Re: 49 CFR Part 573; Recall of Mercedes-Benz M-Class

Campaign No. 2003040005 May 2003
 Revised June 2003,
 Revised July 2003,
 Revised November 2003

SUBJECT: **MODEL 163.154/157/172/174/175
 REPLACEMENT OF CLAMP FOR LOWER POWER STEERING HOSE DUE TO
 POSSIBLE FLUID LOSS AT RADIATOR**

This revised Recall Campaign bulletin 2003040005 supercedes previously issued Recall Campaign bulletin 2003040005 released in July 2003. It contains new and updated work instructions and warranty information. The revised work instructions provide for replacement of both the hose clamp and lower power steering hose at the same time to eliminate the intervening testing procedure. Replacement parts sets will now be provided in complete packages by model, and where appropriate, model and VIN range. Please destroy all previous Recall Campaign bulletin versions.

Figure 1

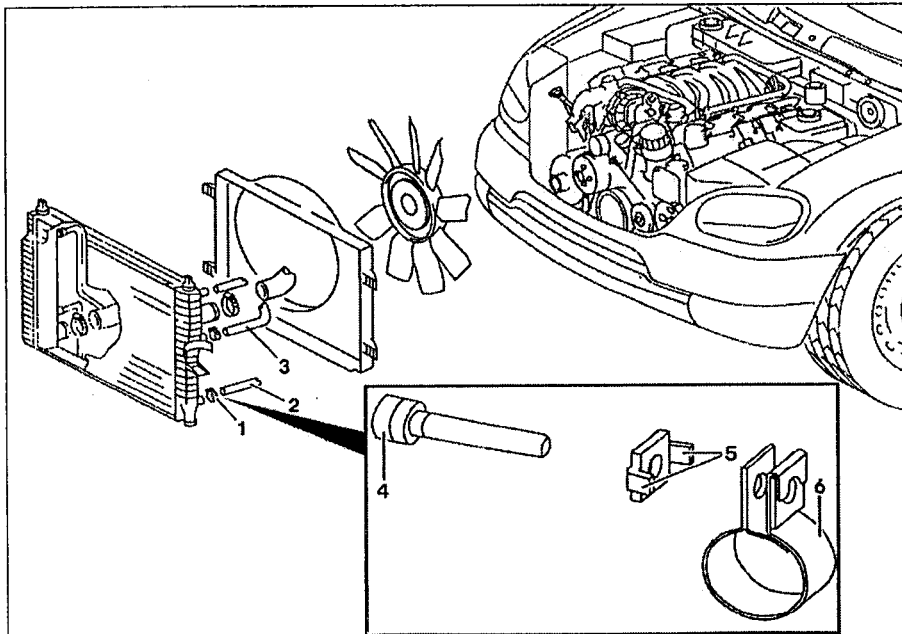
DCAG has determined that the lower power steering hose and hose clamp (1 and 2, Figure 1) at the lower left hand corner of the radiator must be replaced. The hose clamp may not provide sufficient clamping force for this connection and may cause fluid loss.

- 10. Install new power steering hose (2, Figure 1) in reverse order. (use new hose clamp, as provided in the repair kit).
- ⓘ Install **new** sealing rings (11, Figure 2) or rubber O-ring as applicable when installing new lower power steering hose (2)

- 11. As equipped: torque banjo bolt to 30 Nm or flare fitting with O-ring to 45 Nm, see WIS document: AR46.30-P-0500B
- 12. Slide the installed new hose clamp toward the radiator and locate in the proper position on the lower steering hose (1, Figure 1) as shown and tighten hose clamp screw (6, Figure 2).

- ⓘ Observe tightening torque of: Nm 2.0 + .5 / - 0.0 and proper orientation of the anti-rotation tabs (5, Figure 1).

Figure 2 (sealing ring vehicle shown, vehicles with flare fitting and O-ring may be different)

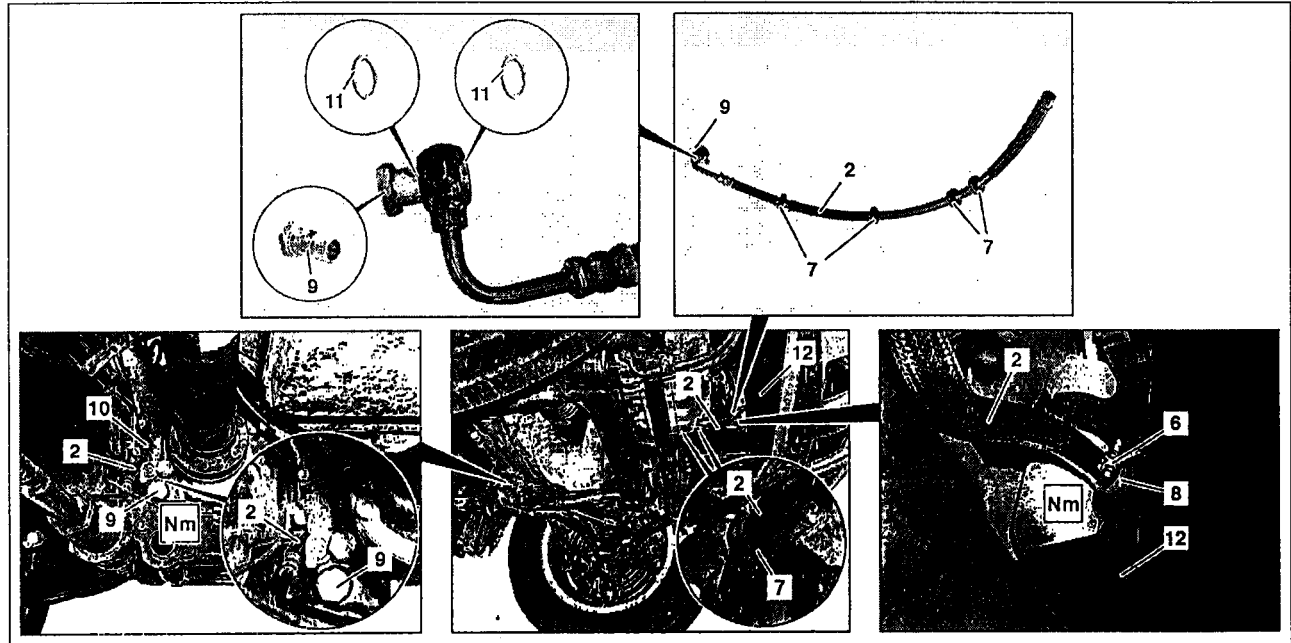
- ⓘ Before removing hose, observe orientation of lower power steering hose at steering rack to ensure proper positioning of replacement hose.
- 7. Detach lower power steering hose mounting grommets (7, Figure 2) from 4 holders (attached to the frame rail on the left front of vehicle).

- 8. Loosen hose clamp (6, Figure 2) and disconnect lower power steering hose (2) from radiator fitting.
- 9. Remove banjo bolt (9, Figure 2) securing lower power steering hose (2) to power steering rack (10) and remove power steering hose by routing out towards rear of vehicle.

- ⓘ Carefully clean lower power steering hose connection (8, Figure 2) at the radiator, using a lint-free shop towel to ensure that no power steering fluid residue is present on the hose connection. Install the lower power steering hose **DRY** onto the hose connection (8, Figure 2) at the radiator (12, Figure 2).
